Sunlight and Neighborhood: A Revised Plan for Riverside Center

August 2009

RIVERSIDE CENTER

Riverside Center Current Plan

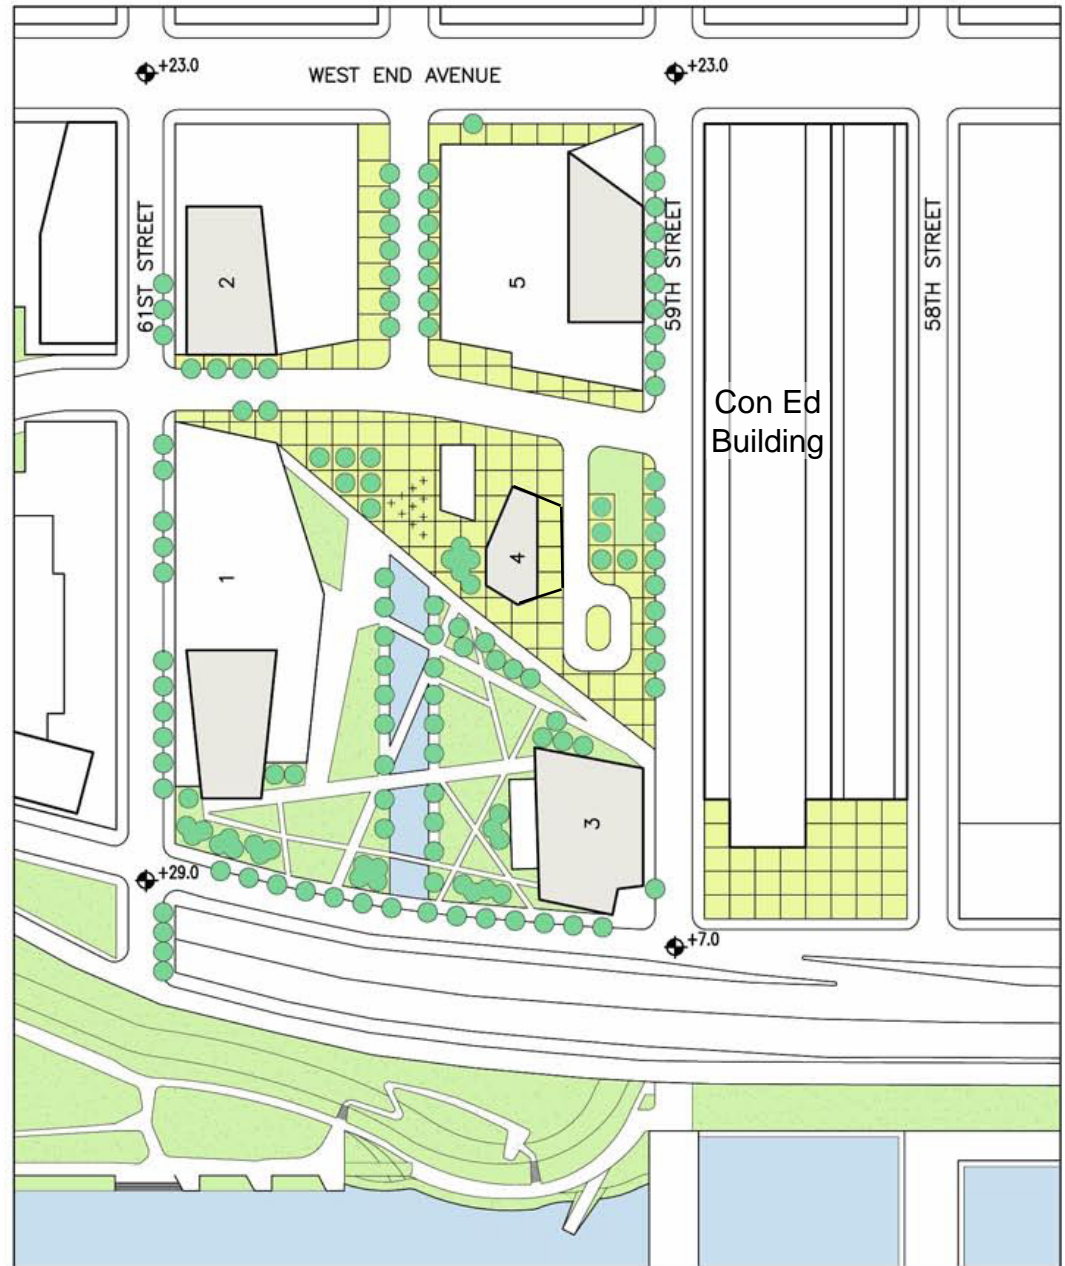
A major strength is a strong east-west path that widens as it heads west toward the river.

Its main weakness is its inward orientation, turning its back on the neighborhood and the Con Edison building, creating an elegant park that does not invite you to stay.

The weaknesses, recognized by Community Board 7, have a simple solution which forms the basis for our proposal.

Riverside Center Current Plan

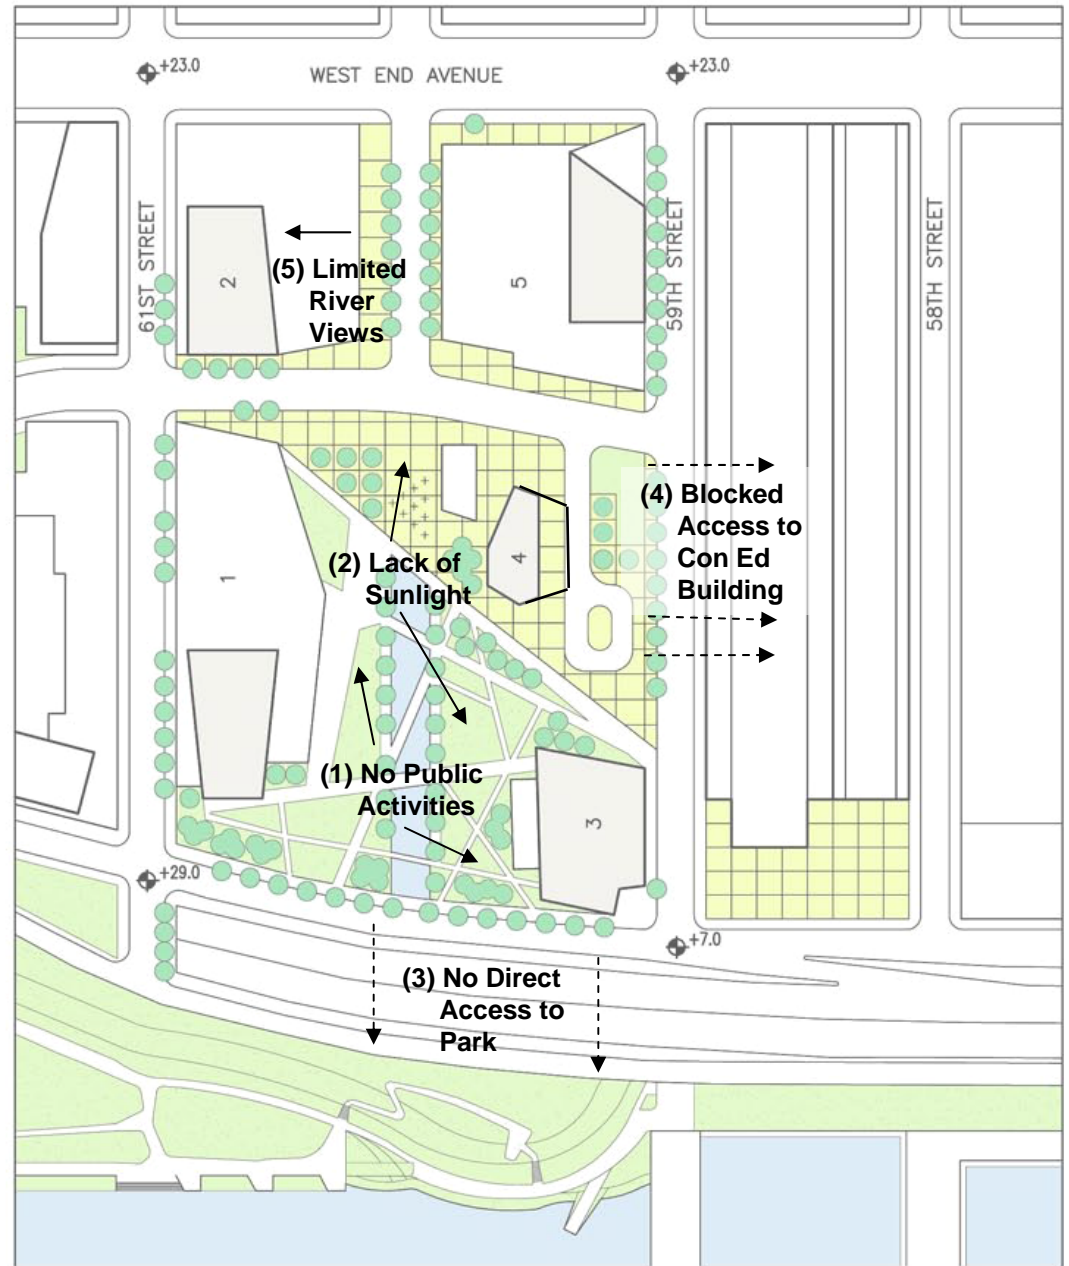
Issue #1: The interior space is semi-private, inward-looking; no public activities for 4800 new apartments in the area

Issue #2: The interior is largely in shadow; needs more sunlight, openness to the neighborhood

Issue #3: No direct access to the waterfront park; no planning for park access over the future relocated highway

Issue #4: No direct access to or broad view of the historic Con Edison building to the south

Riverside Center Current Plan

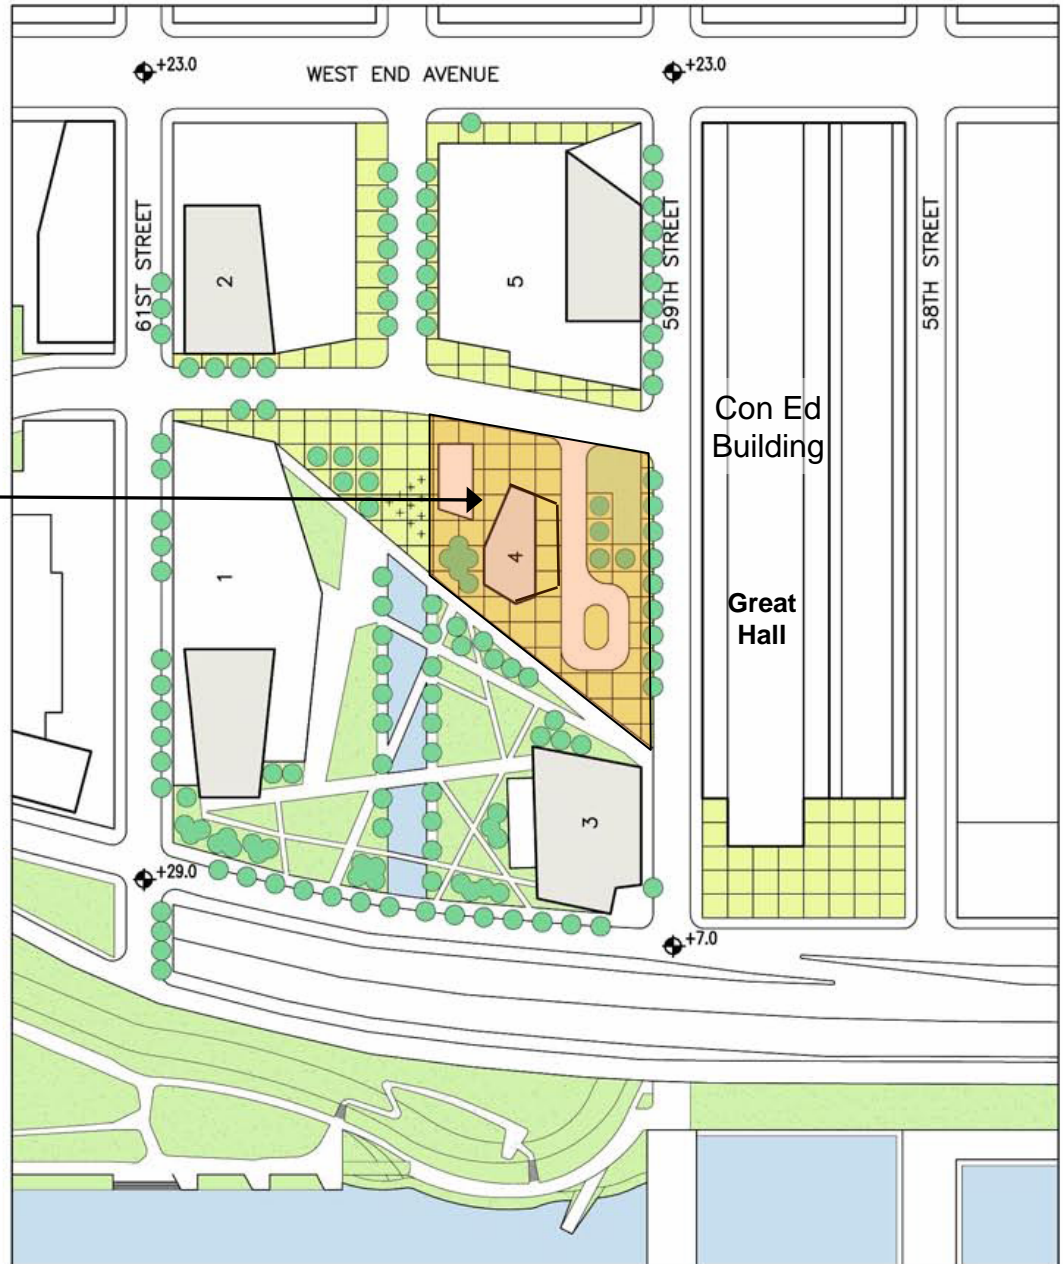
This one acre parcel is well situated to solve the identified open space problems. The solution entails the elimination of Building 4 (350,000 sq. ft.) as well as the adjacent service road.

Riverside Center Revised Plan

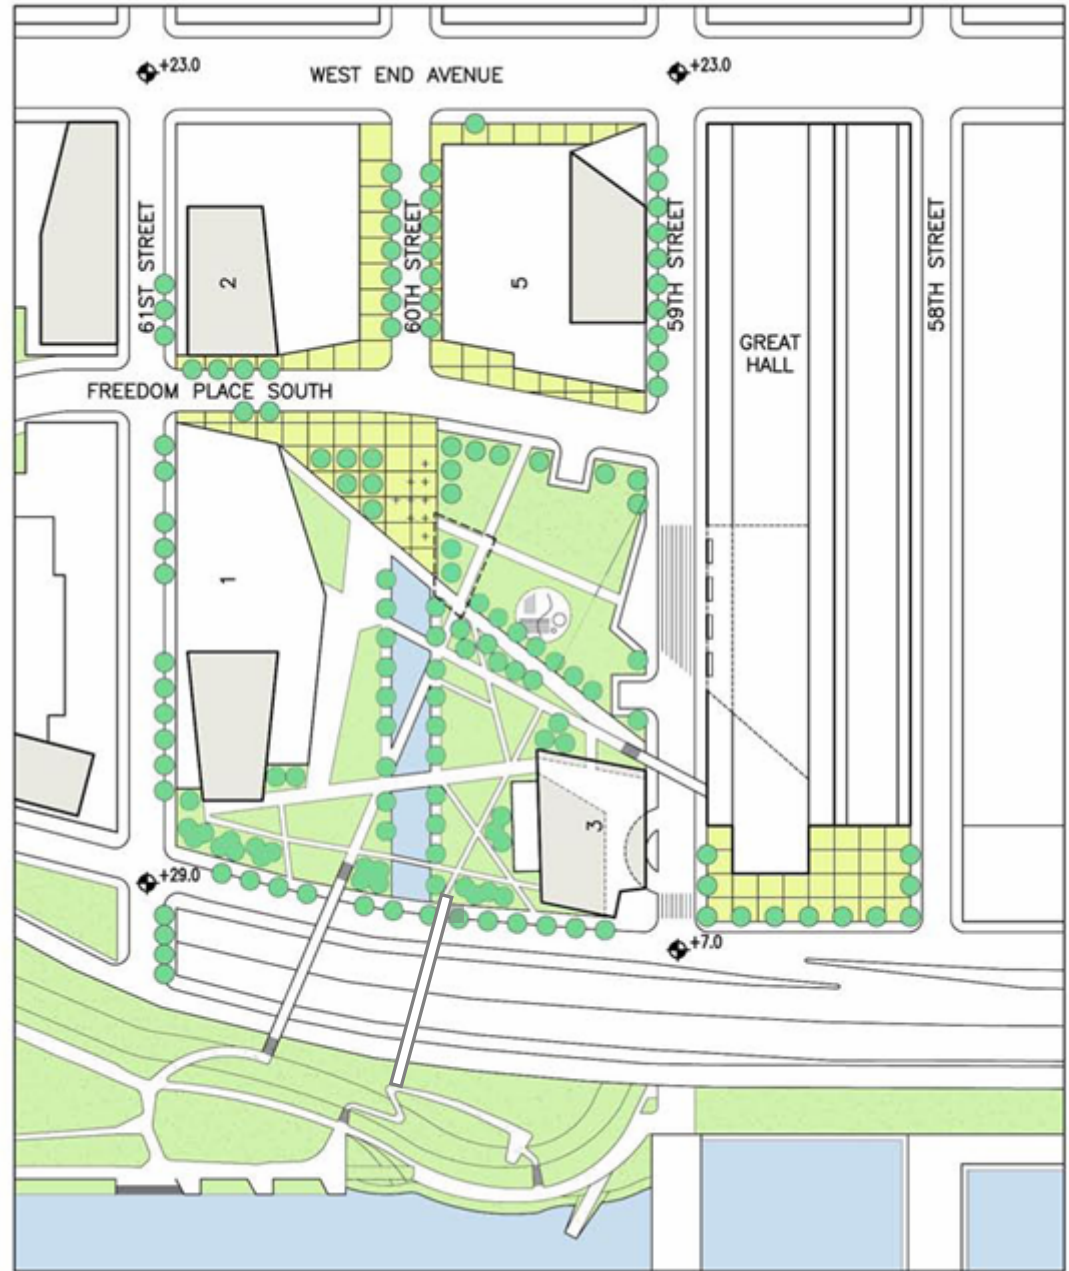
1. Opens up plan to neighborhood, brings in sunlight over broad swath.
2. Provides separate activity space for public use — recreation, play.
3. Brings Con Edison building into the plan for access and visibility — the “fourth wall.”
4. Provides for direct access to waterfront park via bridge over future highway.
